**ASSESSMENT OF THE  
PROPOSED DARWIN  
RENDERING PLANT**

MARCH 1983

CONSERVATION COMMISSION OF THE NORTHERN TERRITORY  
DARWIN N.T.

HUDSON'S CREEK SITE

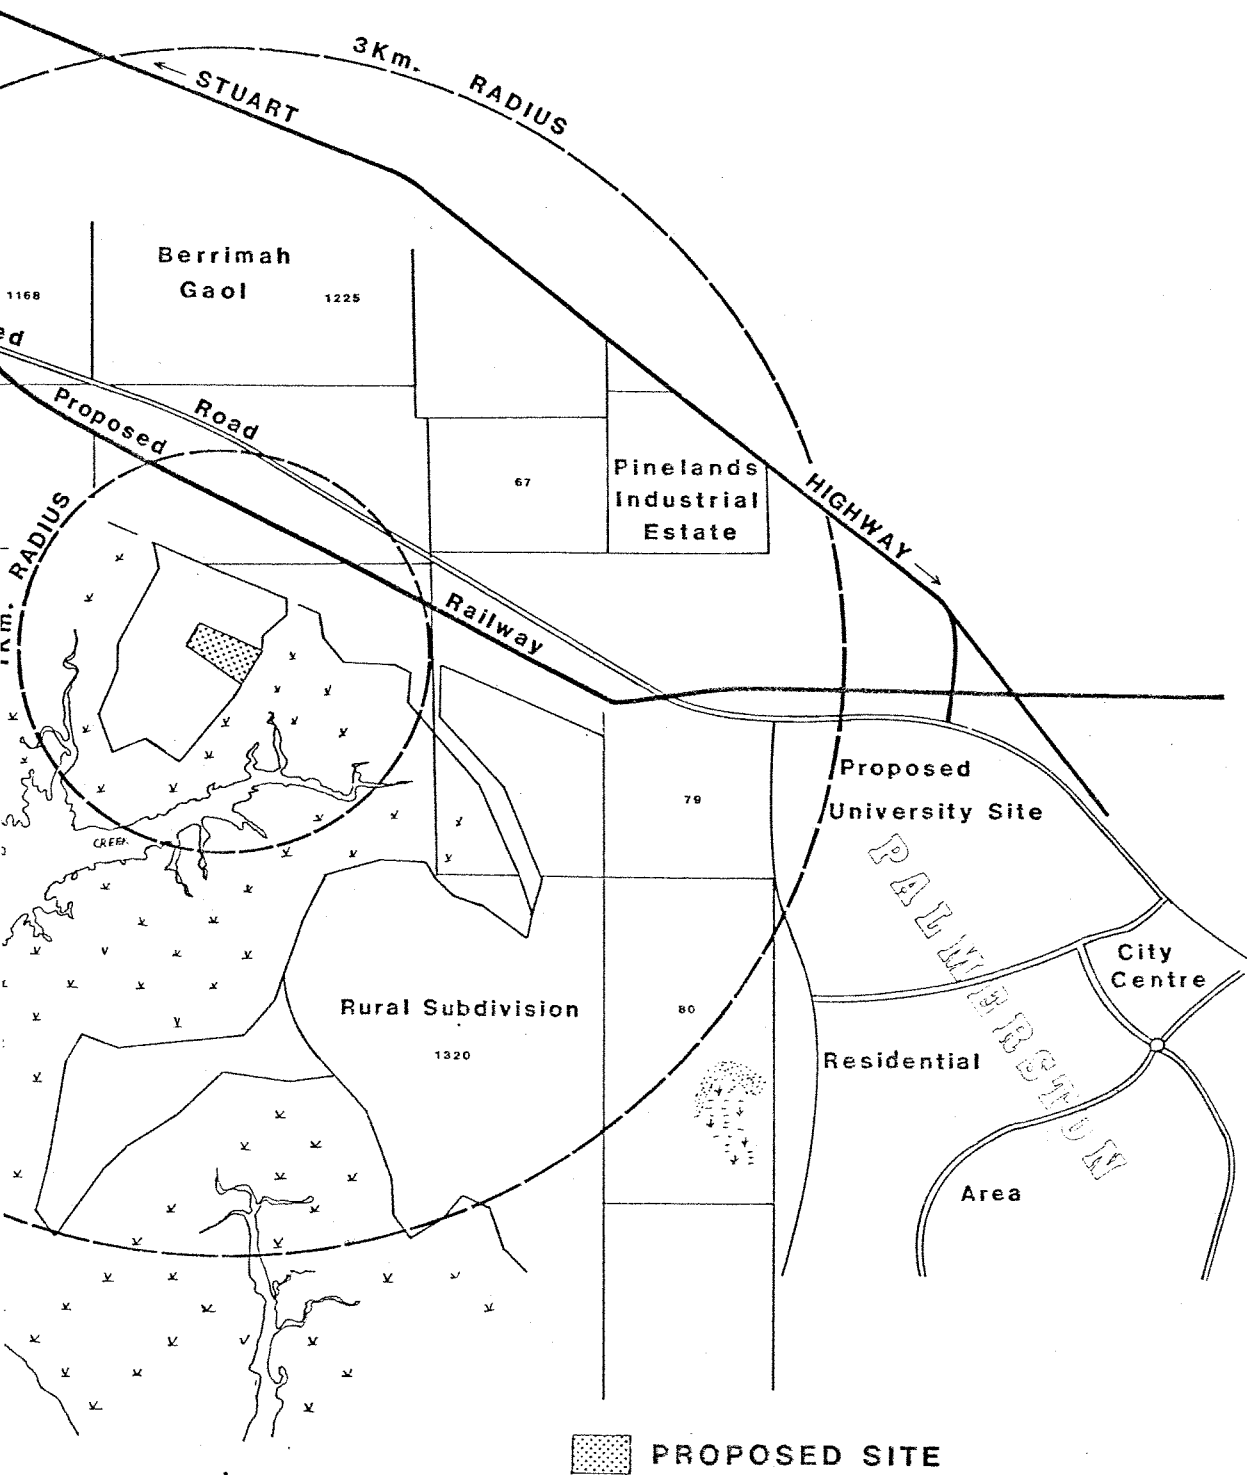
#### 4.1 Hudson Creek (Map A)

Located in a noxious industry zone, this 4.98 hectare site is immediately north of the area currently occupied by Northbrick Pty Ltd, and has power and water available, but is not sewered.

The site is approximately 16 km from central Darwin with road access via the Stuart Highway, turning off immediately east of Angliss Meatworks. Prevailing winds for the area are north-westerly during the wet season (November-April) and south-easterly in the dry (May-September).

ANZAC PARADE SITE

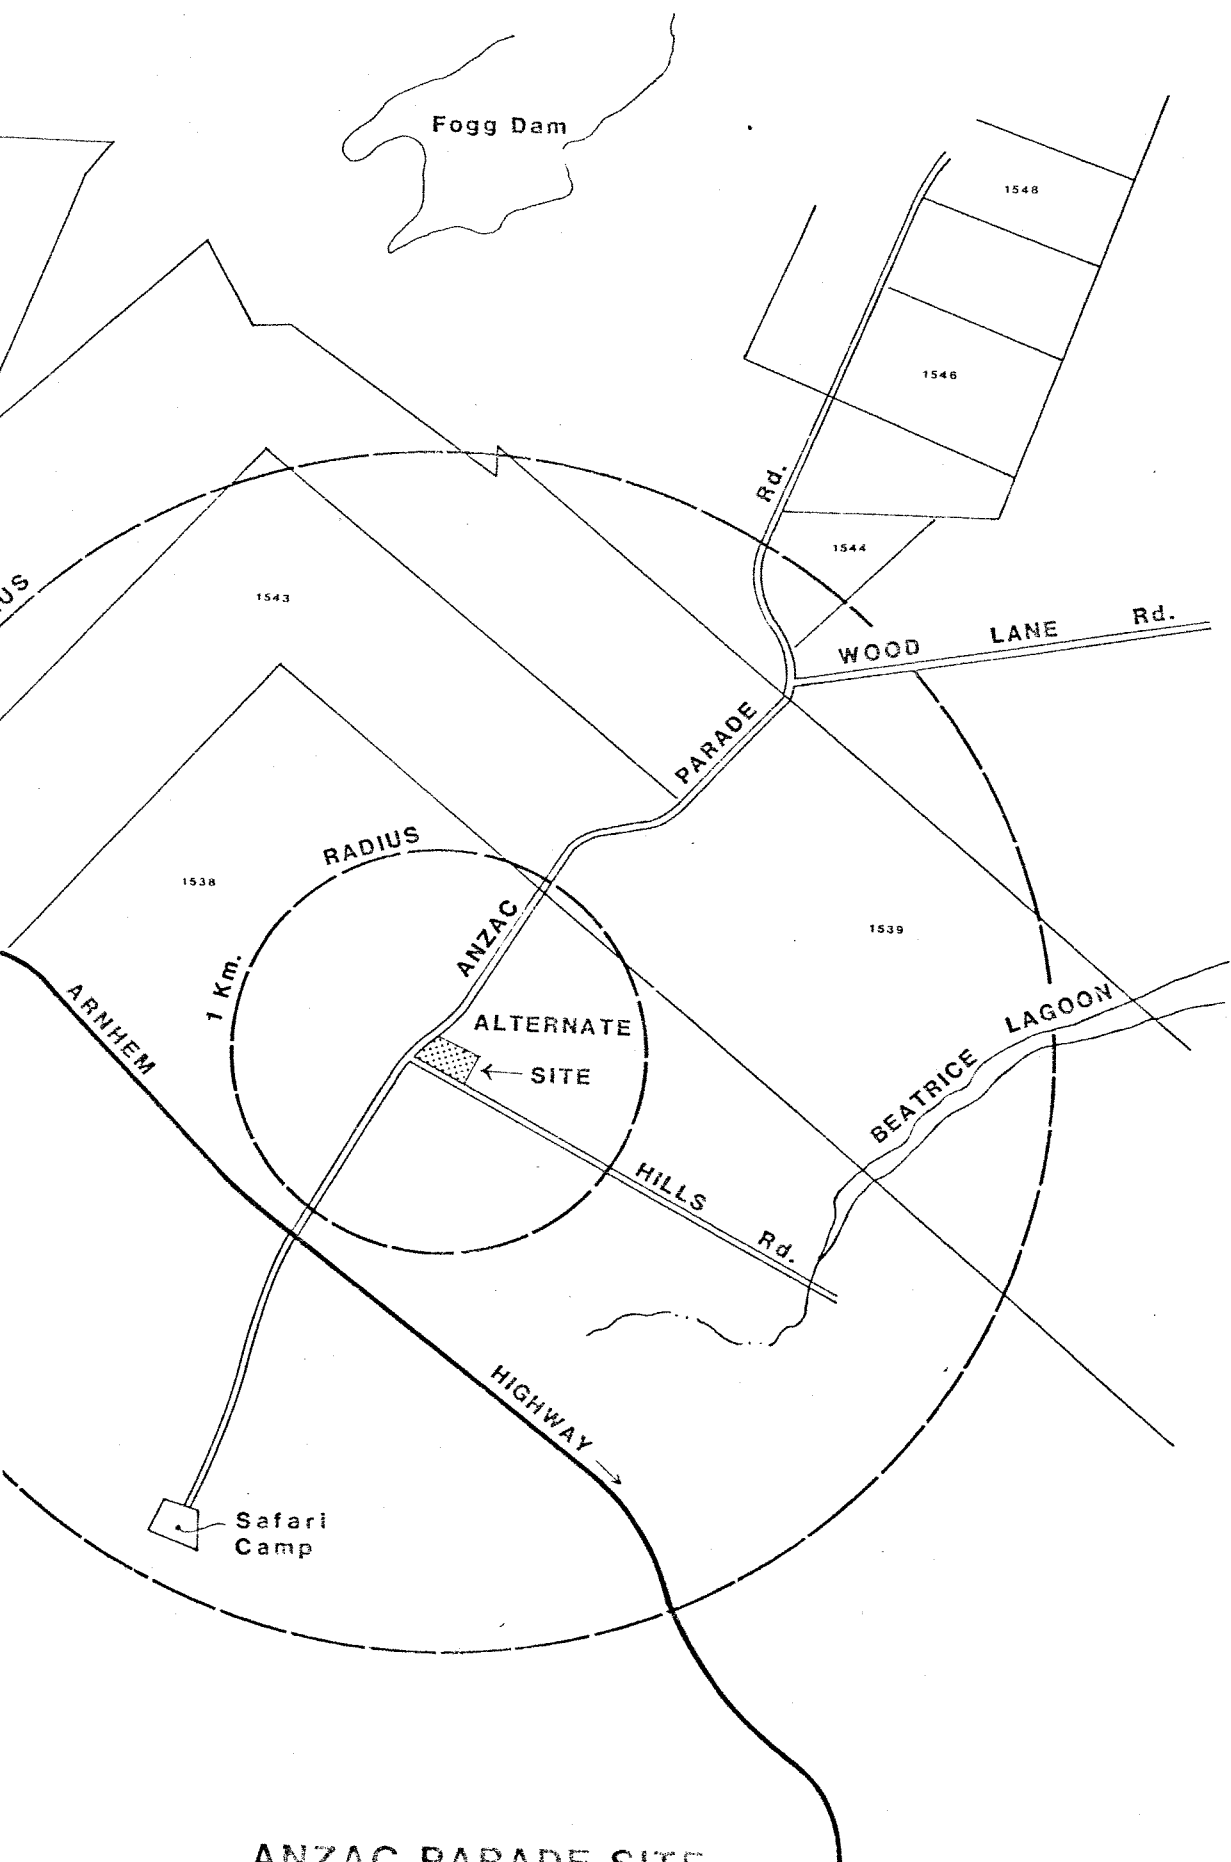
#### 4.2 Anzac Parade (Map B)

This site is located on the corner of Anzac Parade and Hills Road, 4 km north-west of Beatrice Hill in the district of

Humpty Doo. Located approximately 70 km from central Darwin, this site has power supply but is neither sewerred nor watered. Good quality bore water has been obtained locally at a depth of 20 metres or less.
